Office Action Summary	Application No. 10/585,971	Applicant(s) KOLBLIN ET AL.	
	Examiner EMMANUEL DUKE	Art Unit 3744

DETAILED ACTION

Annotate d Fig. 1

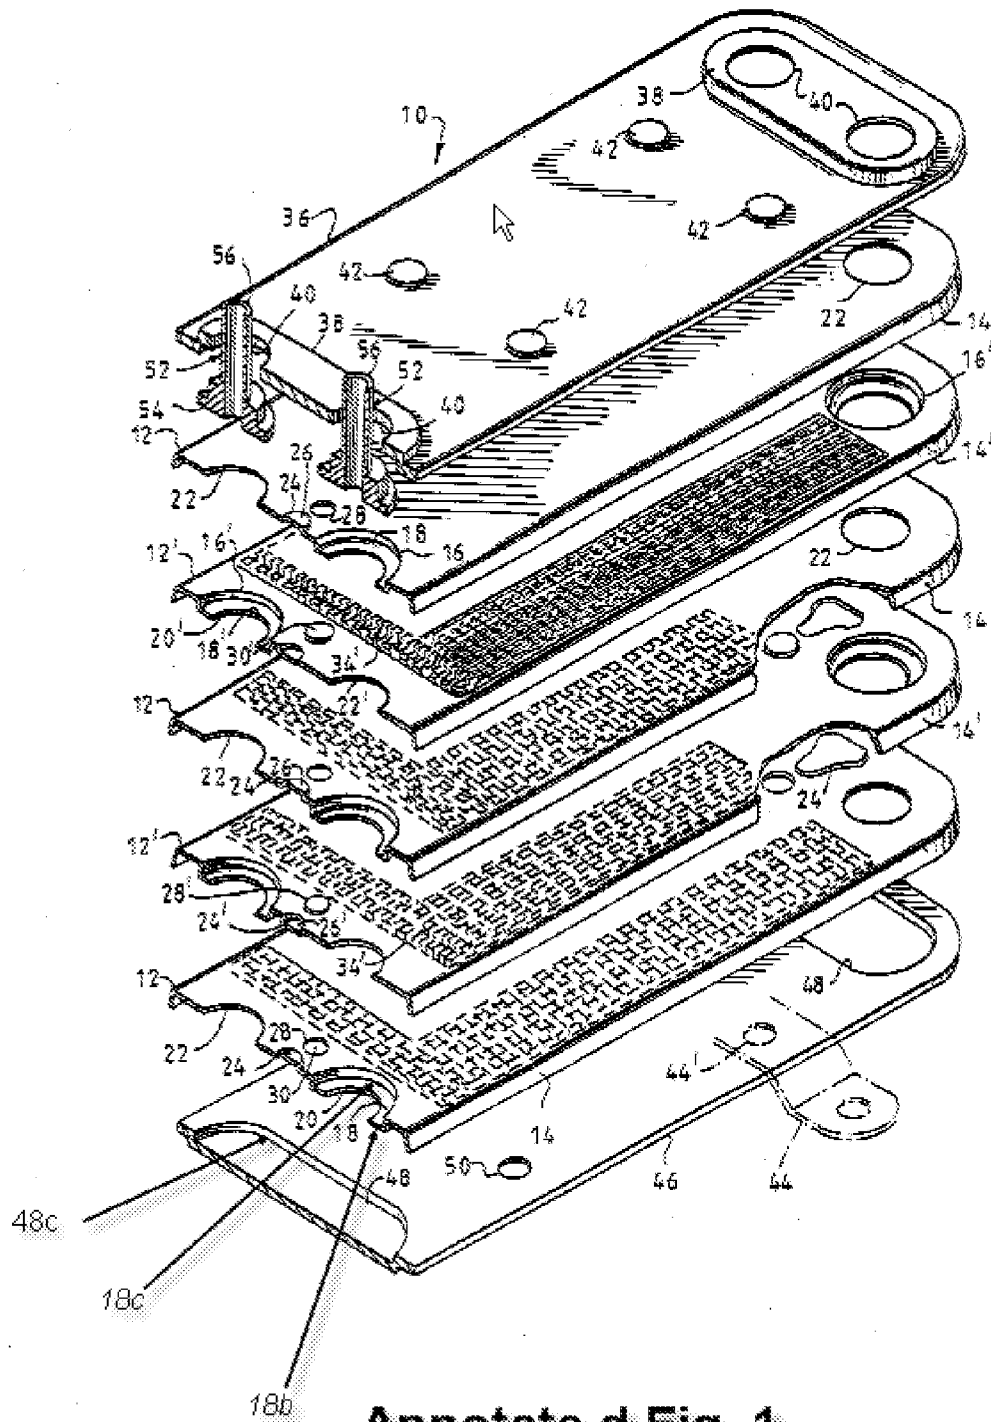
Regarding Claim 1, Fuerschbach et al. '578 disclose a heat exchanger having a plate-type design (10, Fig. 1: Col 3, line 8), comprising: at least two adjacent heat exchanger plates (12, Fig. 1: Col 3, lines 9-10) defining an inter-space (34, Fig. 1: Col 1, lines 21-25 and Col 5, lines 16-22, wherein a flow path between turbulator is an inter-space) through which a heat exchanger medium (Col 1, lines 13-15 and Col 5, lines 14-22, wherein a fluid is a heat exchanger medium); or a second medium: to be cooled or to be heated flows (Col 1, lines 9-15): wherein the at least two adjacent heat exchanger plates are arranged in a stack (Fig. 1: Col 1, lines 9-15), and a base plate (46, Fig. 1: Col 4, line 29, wherein a bottom plate is a base plate), wherein the base plate is provided at one end of the stack (as shown in Fig. 1), wherein the base plate is in at least substantially flat (as shown in Fig. 1) contact with an adjacent outermost heat exchanger plate (Fig. 1: Col 4, lines 55-57) of the heat exchanger, wherein the base plate comprises a depression (48, Fig. 1: Col 4, lines 29-30) with a contour having a shape (see annotated Fig. 1: wherein 48c is a contour having a sharp) that is the same sharp as an outer edge (see annotated Fig. 1: wherein 18c is an outer edge) of a bottom surface (see annotated Fig. 1: wherein 18b is a bottom surface) of one of the heat exchanger.

Regarding Claim 2, Fuerschbach et al. '578 discloses the heat exchanger as claimed in claim 1, wherein flanks (14, *Fig. 1: Col 3, lines 13-15, wherein a flange is a flank*) of the outermost heat exchanger plate bear, at least in a lower region of the flanks (*Col 3, lines 15-17*), against flanks of the contour of the base plate, wherein the contour formed by the depression is recessed (*Fig. 1: Col 4, lines 55-59, wherein the contour of the depression is shown as a recessed*) in the based plate.

Regarding Claim 5, Fuerschbach et al. '578 discloses the heat exchanger as claimed in claim 1, wherein the depression in the base plate has a depth (*Fig. 1: wherein a cross-section thickness of the base plate is a depth*) at least as great as a material thickness of one the heat exchanger plates (*Fig. 1: wherein a cross-section thickness of an circular opening (20) as shown, is a material thickness of one of the heat exchanger*) plus half of a clear height (*Fig. 1: wherein half the height of a tabulator (34) is half of a clear height*) between the outermost heat exchanger plate, which bears against the base plate, and a second outermost heat exchanger plate (12' *Fig. 1: Col 3, lines 9-13*).

Regarding Claim 6, Fuerschbach et al. '578 discloses the heat exchanger as claimed in claim 1, wherein the depression in the base plate is at least as deep as a material thickness (*Fig. 1: wherein a cross-section thickness of an circular opening (20) as shown, is a material thickness of one of the heat exchanger*) of one of the at least two heat exchanger plates (*Fig. 1: Col 3, lines 9-13*) of the heat exchanger plus a clear height (*Fig. 1: wherein half the height of a*

tabulator (34) is half of a clear height) between the outermost heat exchanger plate, which bears against the base plate, and a second outermost heat exchanger plate (12' Fig. 1: Col 3, lines 9-13).

Regarding Claim 13, Fuerschbach et al. '578 discloses the heat exchanger as claimed in claim 1, wherein the contour of the depression has a shape (Fig. 1: Col 4, lines 29-30, wherein depression oval shape is a shape) that matches a shape of an outer edge of a bottom surface (Fig. 1: Col 4, lines 55-59, wherein the contour shape of a annular base portion is a shape of an outer end edge of a bottom surface) of the one heat exchanger plate.

In response to Applicant's argument set forth on page 5, the examiner maintains that Fuerschbach et al. '578 cited reference anticipates claims features of the present application as claimed. See Fig. 1: Col 3, lines 8-32, wherein Fuerschbach et al. '578 discloses a plate type heat exchanger includes at least two adjacent of heat exchanger plates, wherein the at least two adjacent heat exchanger plates are arranged in a stack see Col 1, lines 9-13, and a base plate 46, wherein the base plate is provided at one end of the stack as shown in Fig. 1: wherein the base plate comprises a depression 48 with a contour having a sharp 48c that is same shape as an outer edge outside section outside or opposite to 18c of the bottom surface of one of the heat exchanger plate. Therefore, the argument of Applicant's that Fuerschbach et al. '578 "depression of the bottom plate has a contour with a sharp that is not the same sharp as an outer edge of a bottom surface of the heat exchange" are neither correct nor persuasive. Secondly, Fuerschbach et al. '578 discloses only one outer edge outside section of surface 18c of annotated Fig. 1 of bottom surface of one of the heat exchanger plate 12 with the sharp that is the same sharp contour sharp of the depression 48 of the bottom plate 46. Therefore, the argument of Applicant's that Fuerschbach et al. '578 "depression 48 has a contour formed by a single, long oval while the plate 12 has two circular depression 16 of annular base portion 18 that are much different in sharp from the depression 48 of the bottom plate 46" are neither correct nor persuasive.
